Access Compliance Report

Public Rights-of-Way

Intersection ID: 10030	Main Street: E_28TH_ST	Cross Street: N_TRYON_ST	Location: N
ADA ID: 969209CEE329	Ramp Type: PerpDiag	Initial Pass/Fail: Fail	Overall Compliance: No
		Severity Score: 55

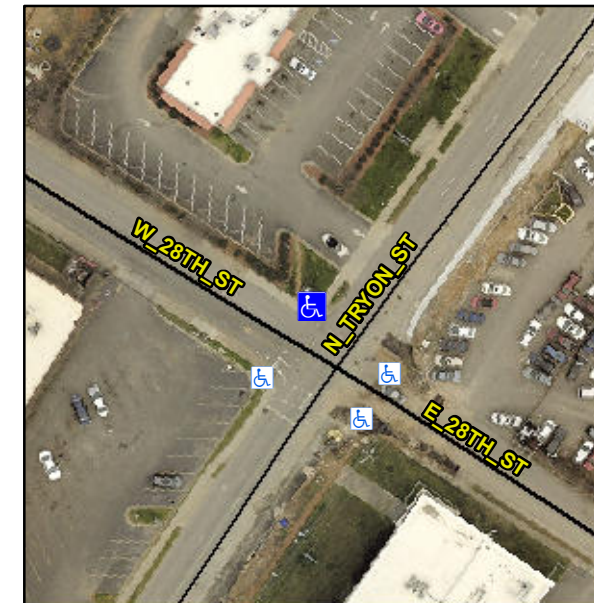
Not Found, R304.5.1, R304.2.2, R304.5.3

Compliance	Description	Data	Compliance	Description	Data
N/A	Ramp Length (in)	59.0	No	Ramp Slope (%)	8.6
No	Ramp Width (in)	34.5	No	Ramp XSlope (%)	12.2
N/A	Flare Type LT	N/A	N/A	Flare Type RT	N/A
N/A	Flare Slope LT (%)	N/A	N/A	Flare Slope RT (%)	N/A
N/A	Flare Traversable LT?	N/A	N/A	Flare Traversable RT?	N/A
N/A	Landing Length (in)	N/A	N/A	DWS Provided?	N/A
N/A	Landing Width (in)	N/A	N/A	DWS Contrast?	N/A
N/A	Landing Slope (%)	N/A	N/A	DWS Length (in)	N/A
N/A	Landing X Slope (%)	N/A	N/A	DWS Full Width?	N/A
N/A	Landing Curb? (Y/N)	N/A	N/A	DWS Offset (in)	N/A
N/A	Shared Landing?	N/A			
N/A	Gutter Ponding?	N/A	N/A	Gutter Slope (%)	N/A
N/A	Gutter Lip Ht (in)	1.0	N/A	Gutter X Slope (%)	N/A
N/A	Painted X Walk1?	Yes	N/A	Painted X Walk2?	Yes
	X Walk 1 Direction	To SW		X Walk 2 Direction	To SE
N/A	X Walk 1 Width (in)	104.5	N/A	X Walk 2 Width (in)	118.0
	X Walk 1 Slope (%)	6.4		X Walk 2 Slope (%)	3.3
	X Walk 1 X Slope (%)	3.9		X Walk 2 X Slope (%)	4.0

Remove & Replace Curb Ramp With Two New Directional Ramps or Equivalent.
